DISTRIBUTION CODE MODIFICATION PROPOSAL FORM

Modification Proposal submitted By: Tony Hearne	DATE OF SUBMISSION OF PROPOSAL: 9 th April 2013	Modification Proposal Number: <i>(to be assigned by Review Panel Secretary)</i> #22
CONTACT DETAILS FOR MODIFICATION PROPOSAL ORIGINATOR: (IF NOT DISTRIBUTION CODE REVIEW PANEL)		
NAME: Tony Hearne	TELEPHONE NUMBER: 01 7026276	
E-MAIL ADDRESS:	tony.hearne@esb.ie	
MODIFICATION PROPOSAL TITLE:	DS3 Fault Ride-Through	
DISTRIBUTION CODE SECTION(S) AFFECTED BY PROPOSAL DCC11.2.1		
MODIFICATION PROPOSAL DESCRIPTION <i>(Clearly state the desired amendment and all text changes. Attach further information if necessary)</i> <ol style="list-style-type: none">1. Replace the current content of DCC11.2.1 with the material shown in Appendix 12. Add the new definitions shown in Appendix 2		
MODIFICATION PROPOSAL JUSTIFICATION <i>(Clearly state the reason for the modification. Attach further information if necessary)</i> Active and Reactive Power responses for the WFPS are to be re-defined to offer a more rapid response from WFPS during and after a system event.

Appendix 1: Distribution Code body content

Figure 9: Fault Ride-Through Capability for Controllable Wind Farm Power Stations connected to the Distribution System.

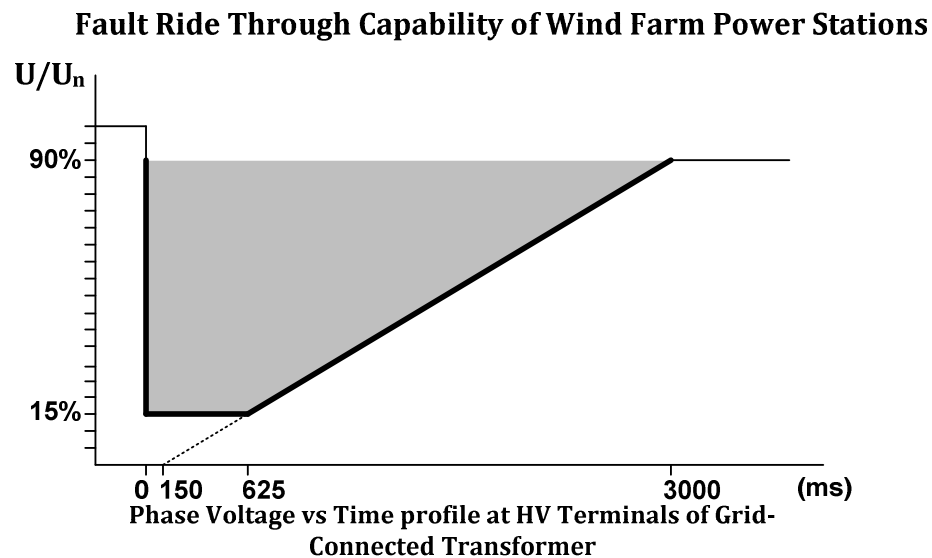
DCC11.2.1 A **Controllable WFPS with Registered Capacity >5MW**, shall remain connected to the **Distribution System** for **Voltage Dips** on any or all phases, **and shall remain Stable**, where the Distribution System Phase to phase Voltage measured at the **Connection Point** remains above the heavy black line in *Figure 9*.
